**WHITE LAKE TOWNSHIP
INTER-OFFICE MEMORANDUM
COMMUNITY DEVELOPMENT DEPARTMENT**

**SUBJECT: Comfort Care White Lake
Rezoning request and preliminary site plan approval**
Property described as parcel number 12-36-176-002, located on the west side of Union Lake Road, between Hutchins Road and Cooley Lake Road, consisting of approximately 8.7 acres. Applicant requests to rezone the property from (LB) Local Business to (PD) Planned Development or any other appropriate zoning district.

RE: Comfort Care Assisted Living- Preliminary Site Plan Review – 4th Review

RE: Comfort Care
Rezoning and Preliminary Site Plan – Review #4

CROSS SECTION MASONRY WALL SW CORNER
NO SCALE

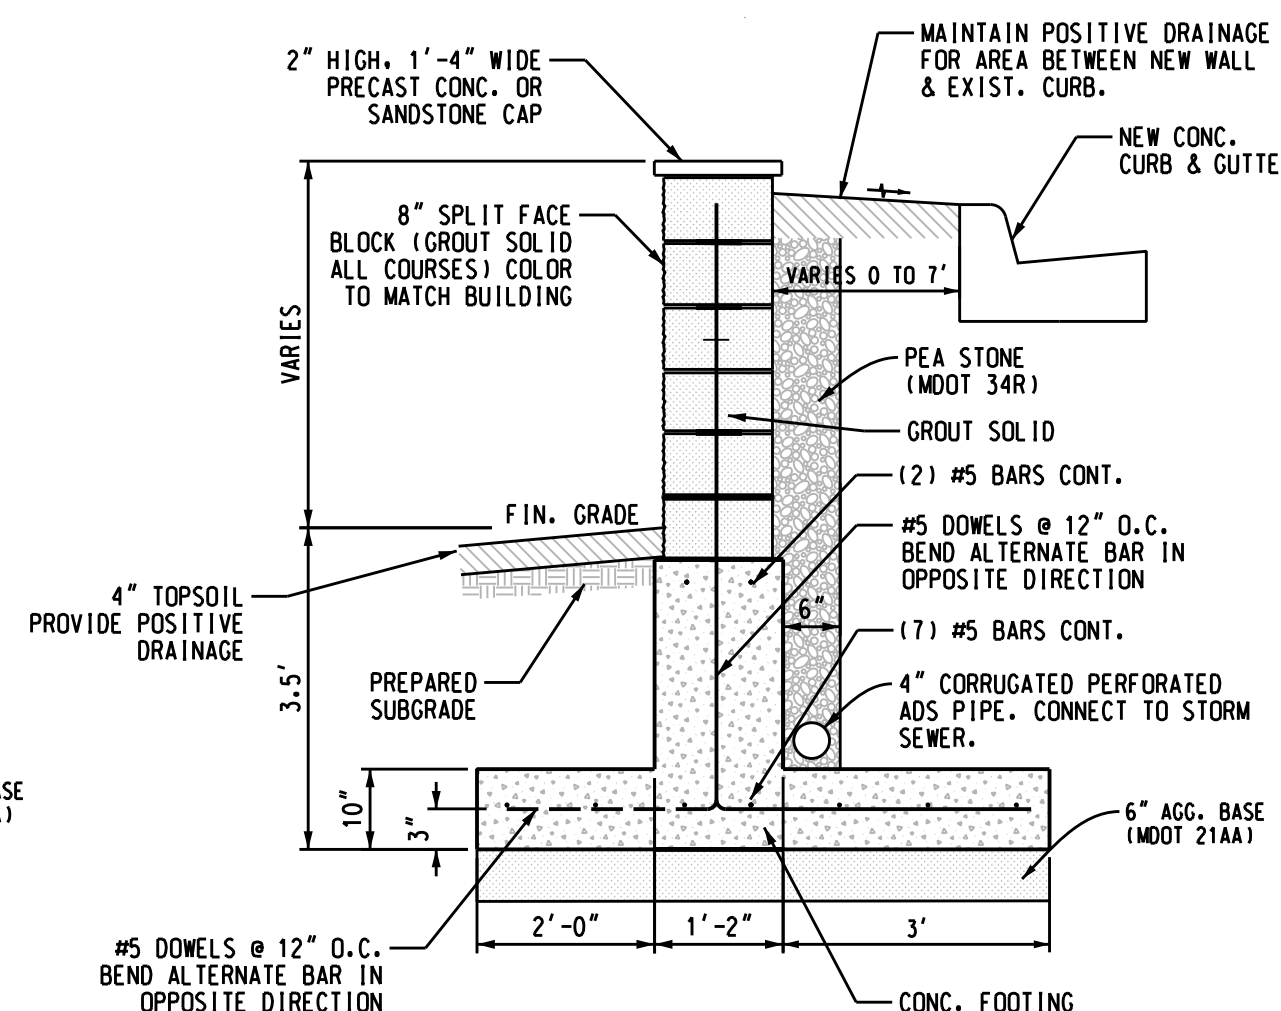
A 20-foot greenbelt is now proposed along the future Union Lake Road right-of-way; therefore, the previously requested waiver from the minimum greenbelt width is no longer necessary. A retaining/screen wall is now proposed along the drive aisle/maneuvering lane parallel to the rear property line. The zoning ordinance requires a screen wall be six feet in height, eight inches in width (faced with a decorative masonry product), with a five-foot greenbelt adjacent to the screen wall for its entire length planted with one large deciduous or evergreen tree and eight shrubs for every 30 linear feet. The masonry wall cross sections on Sheet C600 show the wall is 8-inch split-face block (color to match building) with 2-inch high, 1'-4" wide precast concrete or sandstone cap. The wall detail said the height varies; **the detail shall be revised to indicate a minimum six-foot wall height.**

CONCEPTUAL FLOOR PLAN

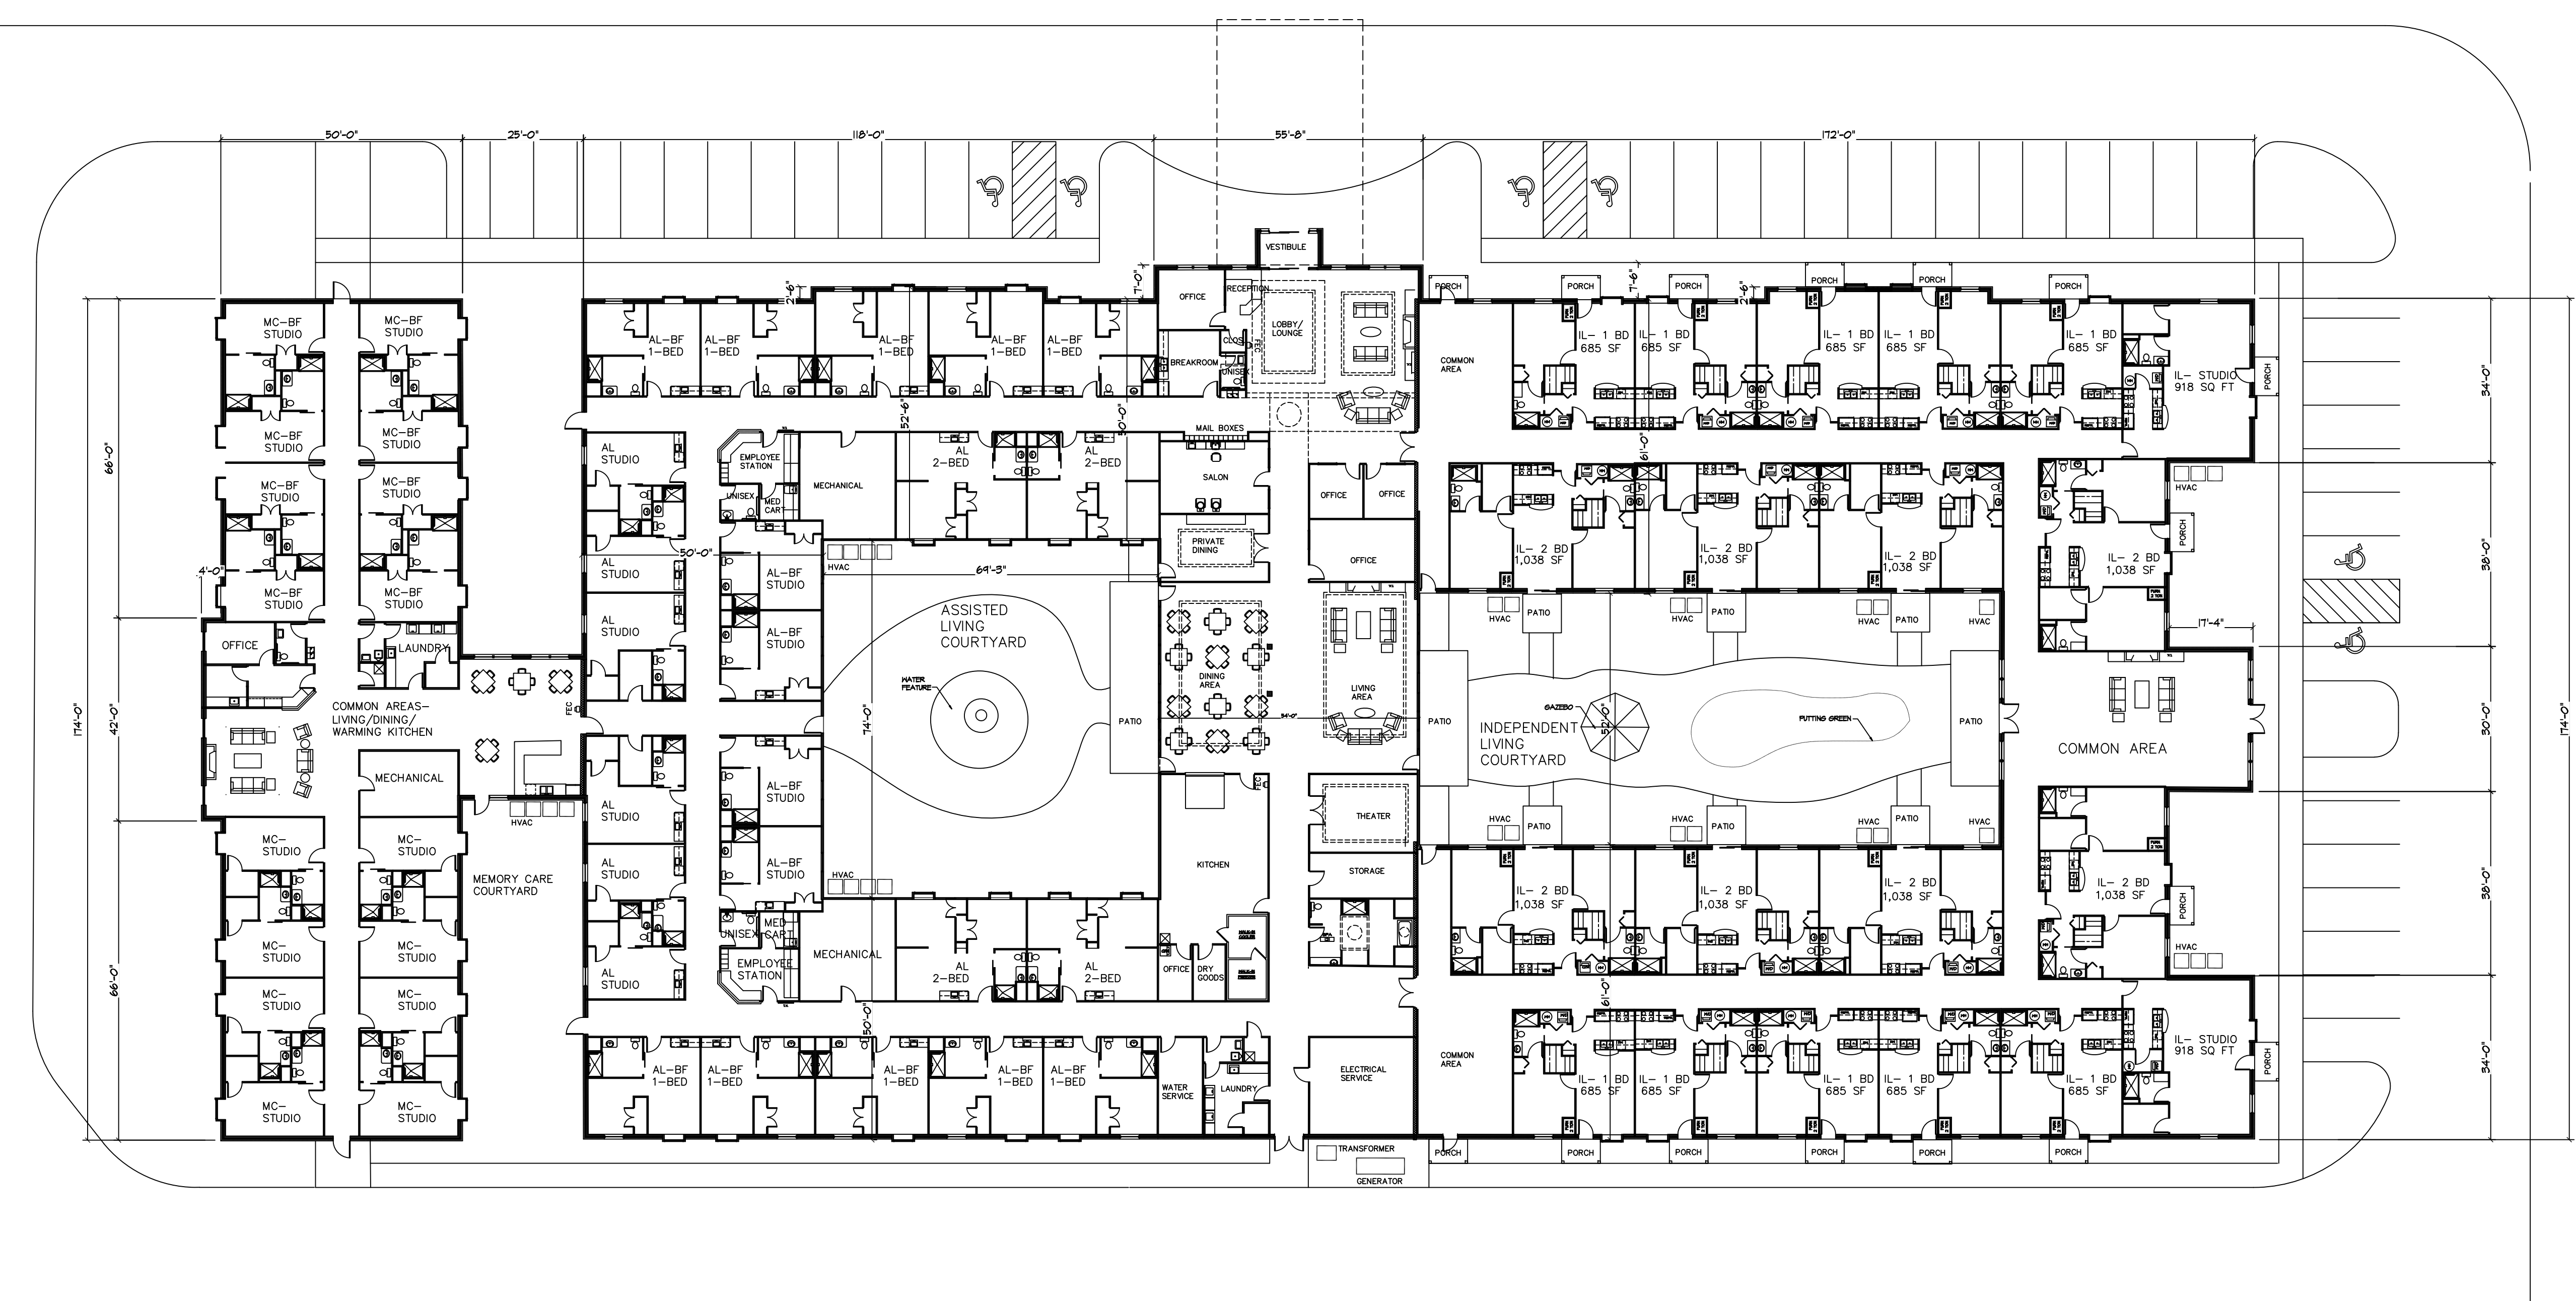
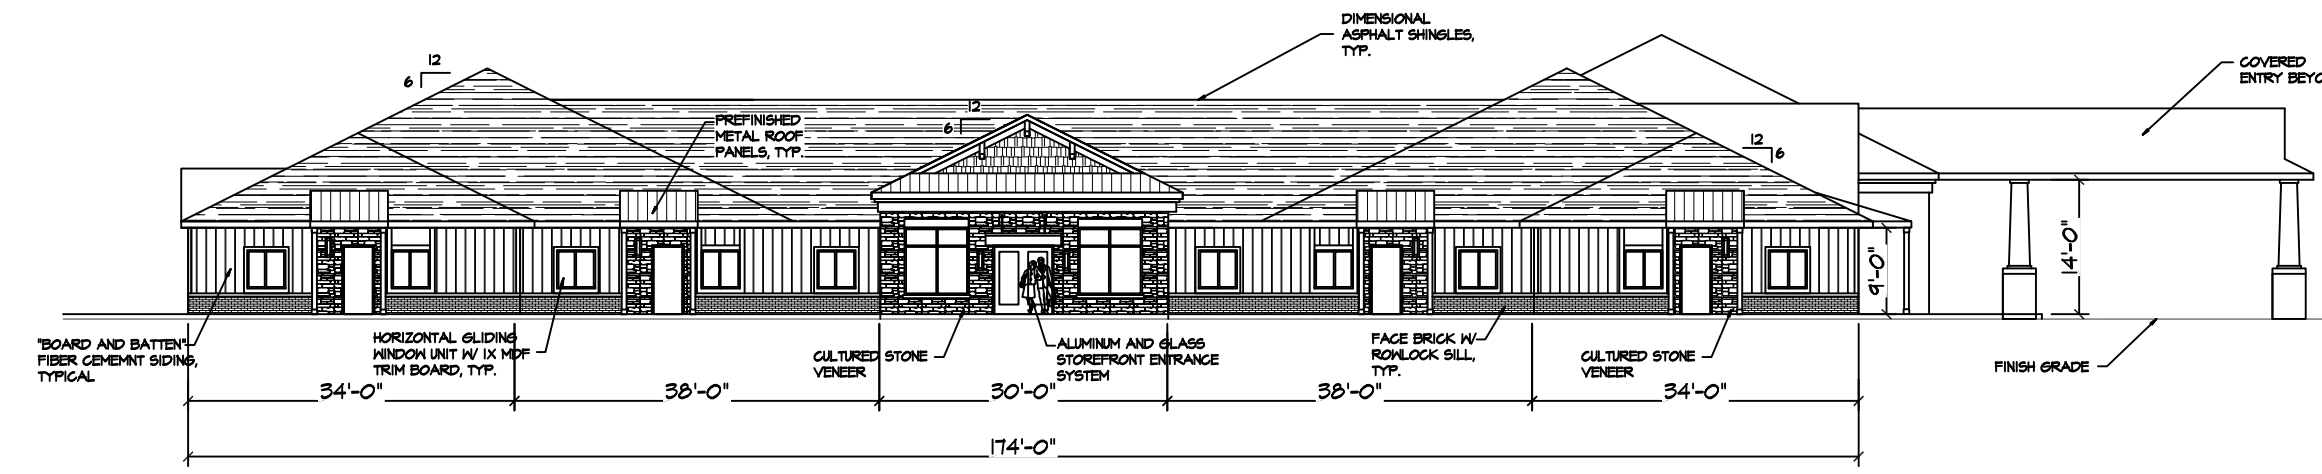
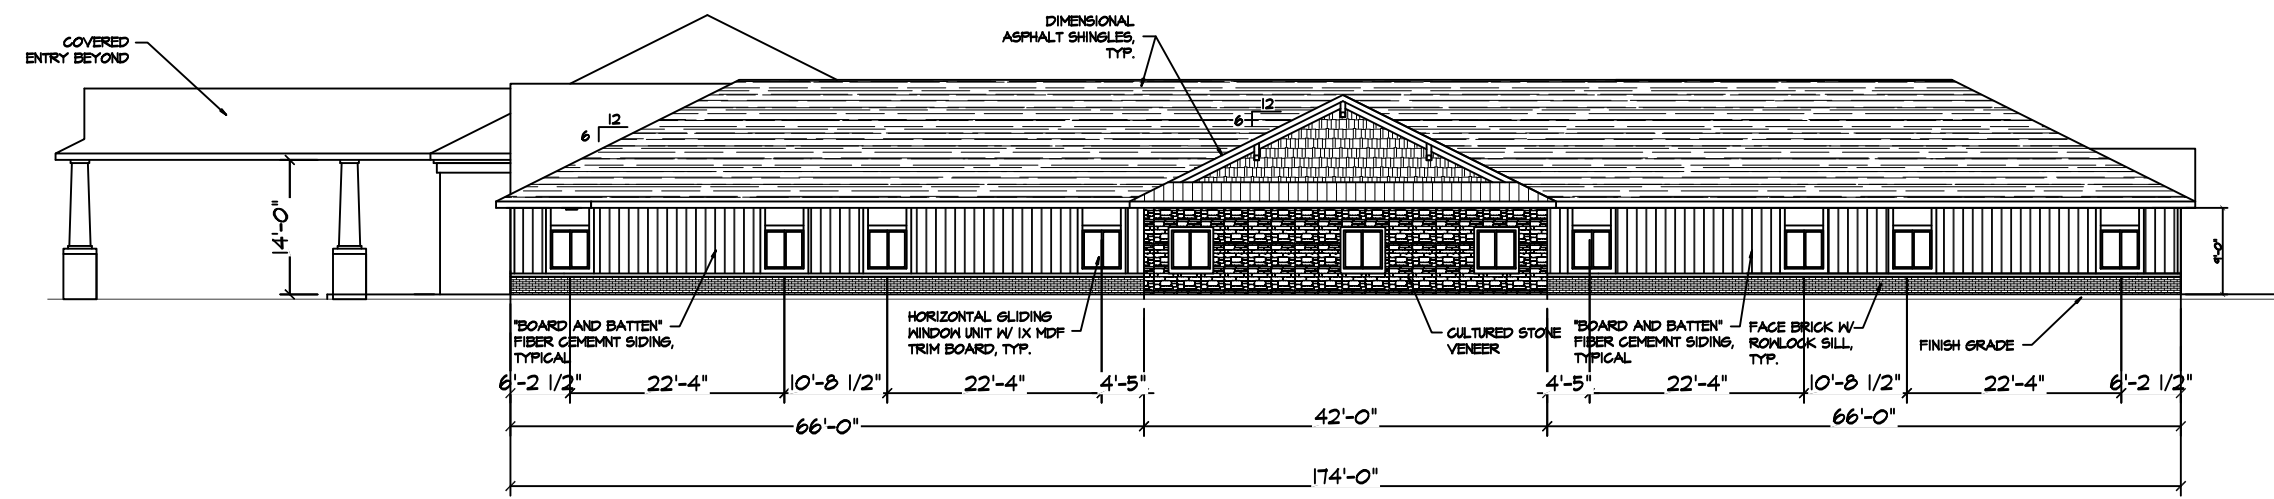
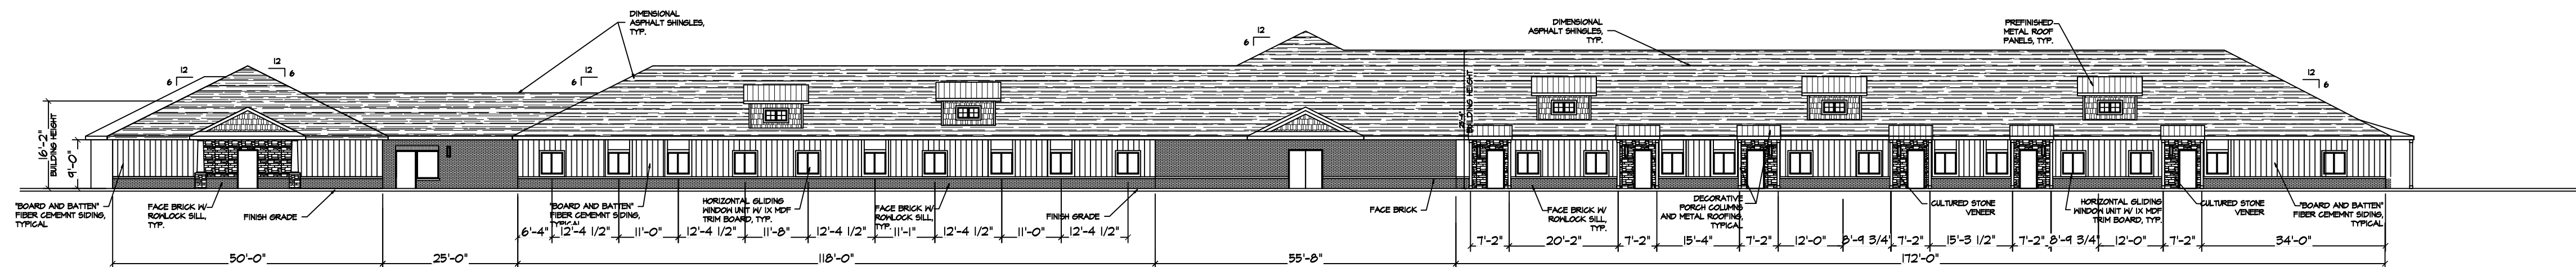
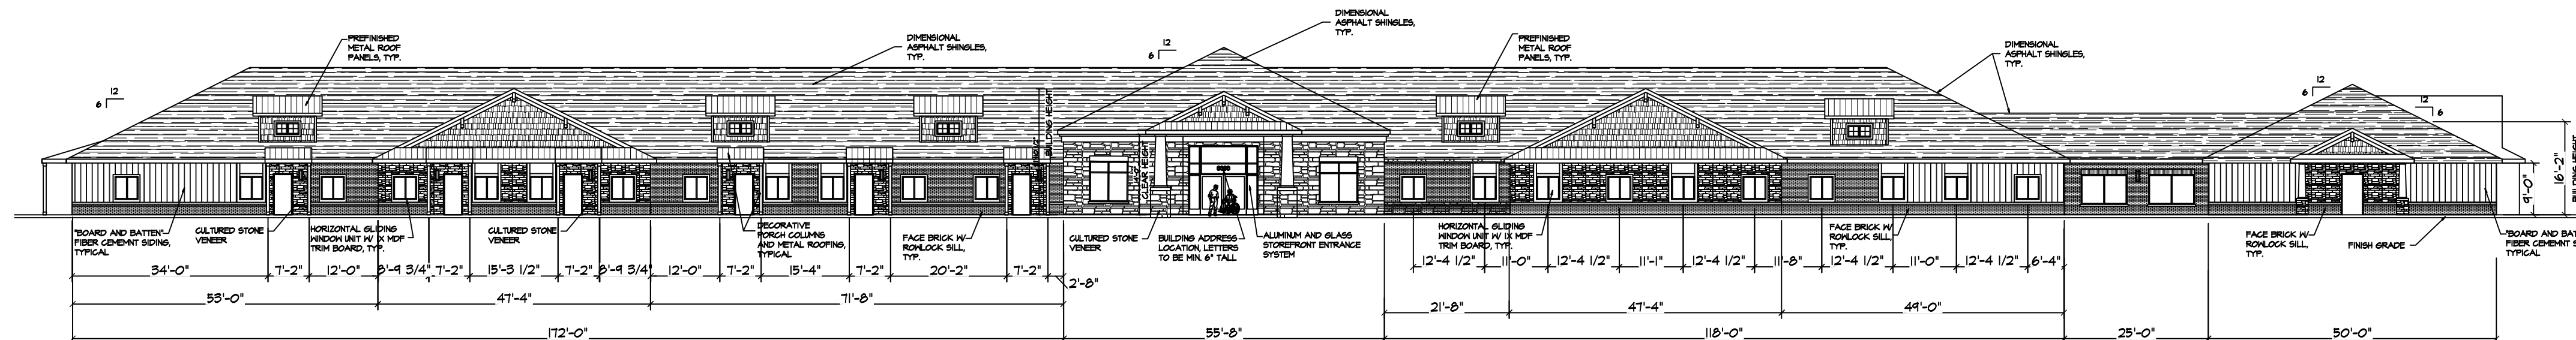
- The Developer’s architect previously indicated there would be bay windows across the front of the building. **Bay windows are not labeled on Sheet A1 or Sheet A2; clarify if bay windows are proposed and revise accordingly.**
